Significant Appraisal Findings

Power Authority of the State of New York  
James A. FitzPatrick Nuclear Power Plant

U.S. NUCLEAR REGULATORY COMMISSION  
OFFICE OF INSPECTION AND ENFORCEMENT

Report No. 50-333/80-20

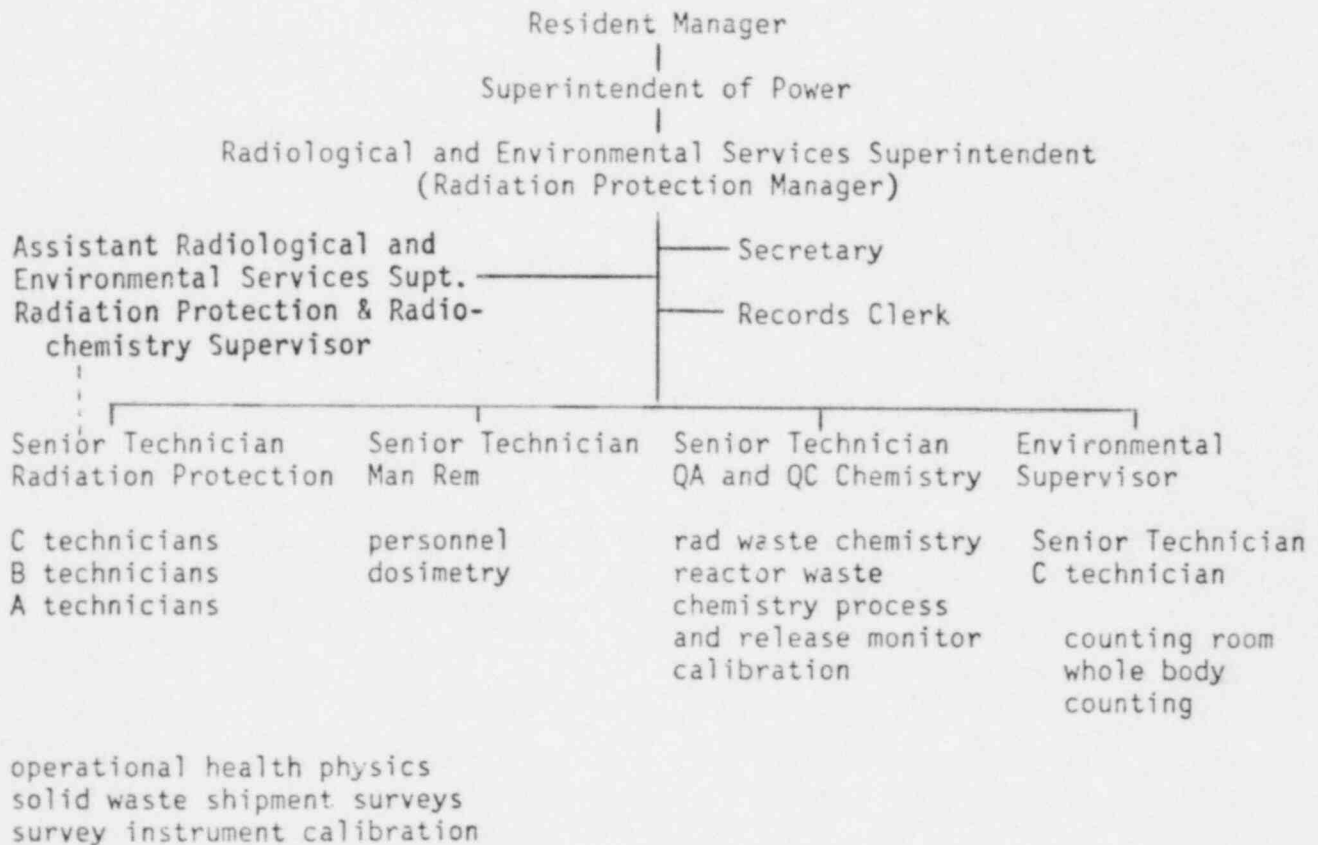
The organization of the RES Department as specified in RES Department Standing Order No. 3, Revision 1, is shown below.

However, the responsibilities of the Assistant RES Superintendent and the Radiation Protection and Radiochemistry Supervisor are so generalized that it is not possible to establish from the standing order what specific duties have been assigned as can be seen from the following direct quotes:

To establish which of the two professional level members of the RES Department were responsible for each of the major aspects of the radiation protection program and which technicians were assigned it was necessary to question the RES Superintendent. There is no documented assignment of these responsibilities.

- Assignments of supervisors and technicians to the major functions of the RES Department should be formally documented (50-333/80-20-01).
- Additional personnel qualified in radiation protection at the professional level should be added to the RES Department. The positions of Assistant RES Superintendent and Radiation Protection and Radiochemistry Supervisor should be filled by separate persons and responsibilities for major functions of the Department should be divided and carried by the appropriate individuals to avoid overloading the RES Superintendent. (50-333/80-20-02)
